CSELR EIS Submission

This Submission to the EIS for the CBD and South East Light Rail project draws out a number of capacity risks that lead this writer to question the adequacy of the project as it is presently proposed.

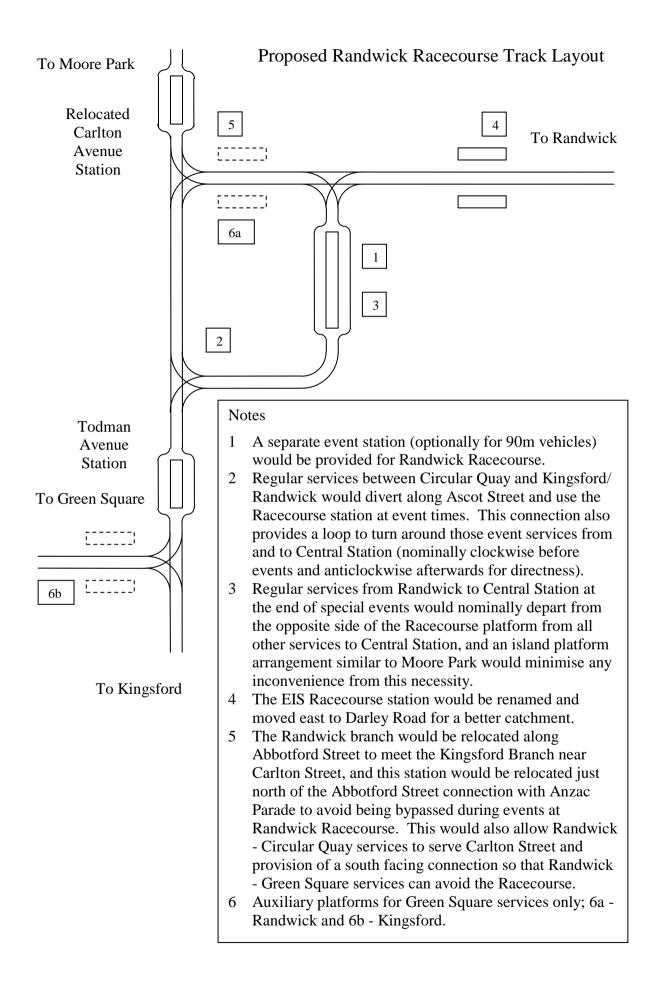
The CSELR EIS in Section 3.1.2.6 of Technical Paper 1 makes reference to developments at Green Square, and notes the availability of rail. However, this is a radial connection with the Sydney CBD to the north. An east west connection between Green Square and the CSELR near Kensington would improve public transport access to POWH/UNSW from a broad area of south and south western Sydney by bypassing a less direct route via Central Station. As well as contributing to the formation of a grid network that can more effectively cater for a wider range of public transport journeys than is possible with a predominantly radial network, this link could also ease some of the specific CSELR capacity risks noted in the main text of this submission.

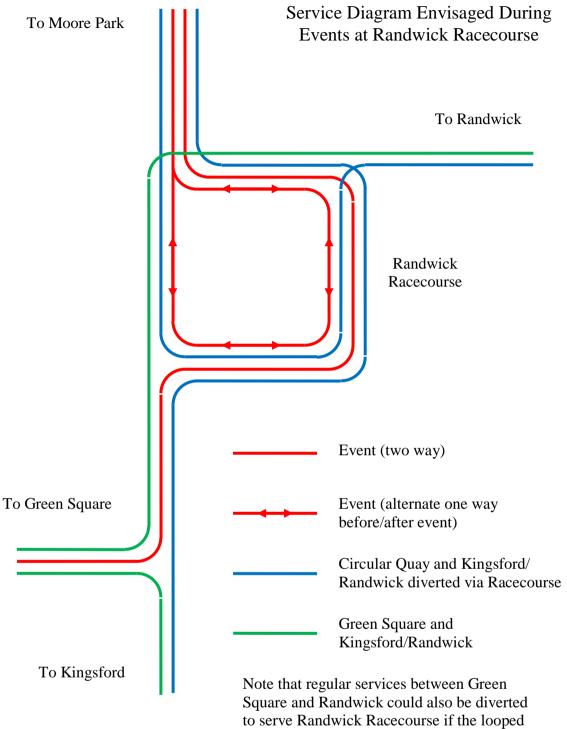
With respect to special events, the access to Green Square would allow the onward rail component of event clearance to occur in both directions from Moore Park and potentially Randwick Racecourse. In practice, demand for services to Green Square would likely be less than for services to Central Station, such that the overall capacity benefit may be around 50%; still enough to ease the service interval pressure on the CSELR for event traffic. A clearance capacity example based on a 2.0 minute service interval (30 LRVs per hour) and only 50% event services towards Green Square (the other empty 50% from Central Station being turned back at the special event point) is shown below:
